Proposal for the 07 series of amendments to Regulation No. 48 (Installation of lighting and light-signalling devices)

Note: The text reproduced below was prepared by the expert from Poland to improve the OICA and GTB proposal in ECE/TRANS/WP.29/GRE/2015/5 introducing new criteria on the automatic levelling of headlamps based on the GTB glare and visibility studies. The modifications to the proposed text are marked in blue bold for new Polish changes or orange strikethrough for deleted characters of the GTB-OICA proposal.

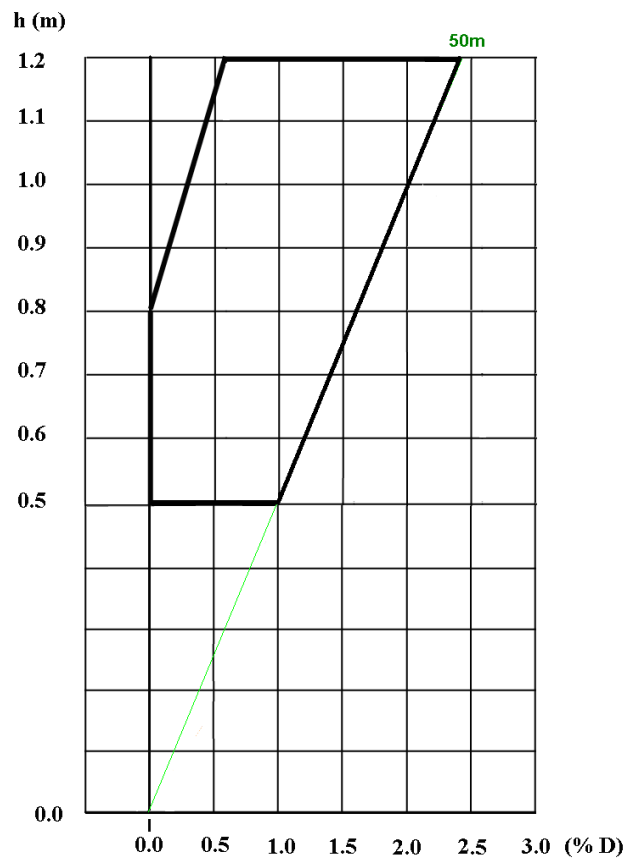
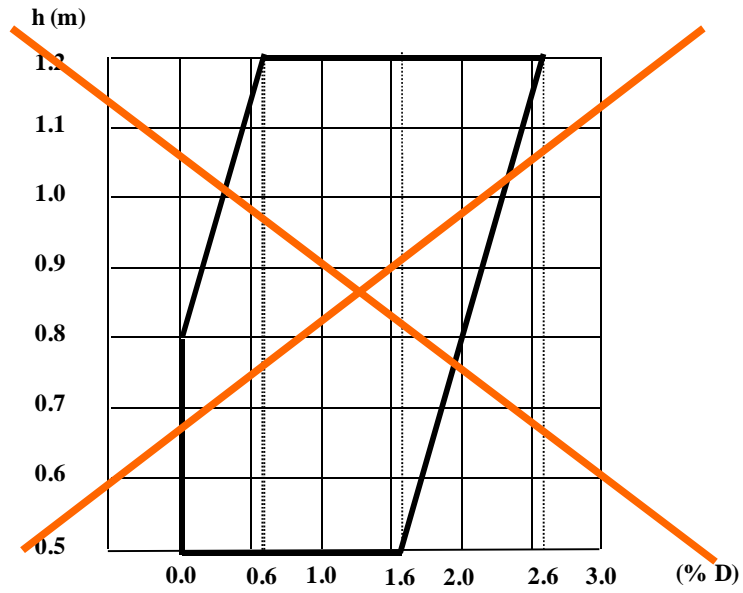
6.2.6.1.1.2. Depending on the mounting height in metres (h) of the ~~lower edge of the apparent surface~~ headlamp reference axis in the direction of the reference axis of the dipped-beam headlamp, measured on the vehicles under the loading conditions prescribed in Annex 5 of this Regulation, the downward inclination of the cut-off of the dipped beam headlamp,

starting from the initial inclination value set by the vehicle manufacturer as prescribed in paragraph 6.2.6.1.1. above, shall remain between the limits (see diagram below):

h = 0.5 m: from 0.0 per cent to ~~-1.6~~1.0 per cent;
h = 0.8 m: from 0.0 per cent to -2.0 per cent;
h = 1.2 m: from -0.6 per cent to -~~2.6~~2.4 per cent

For the intermediate mounting heights, the limits vary linearly between the indicated values.

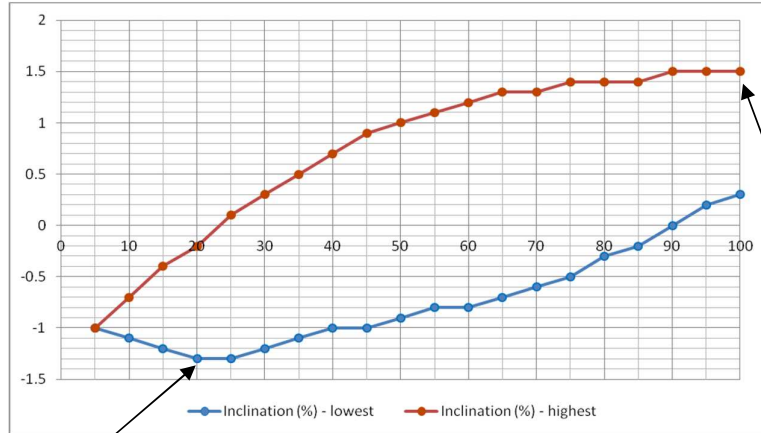
If change of quantity of fuel in tank from reserve to full influences dipped beam inclination more than 0.1% it should be treated as a load factor in two stage: full and reserve respectively to check influence for dipped beam inclination .

The lowest and highest dipped beam inclination loading characteristic should be obtained by measurements according Annex 6.

The lowest dipped beam inclination loading characteristic and the highest dipped beam inclination loading characteristic should be measured according p. 2.2 below and putted in common table and common graph with dipped beam inclination resolution not more than 0.1% and loading resolution not more than 25 kg or 5% of difference between minimum and maximum load.

Example of characteristics is presented in table and on graph below.
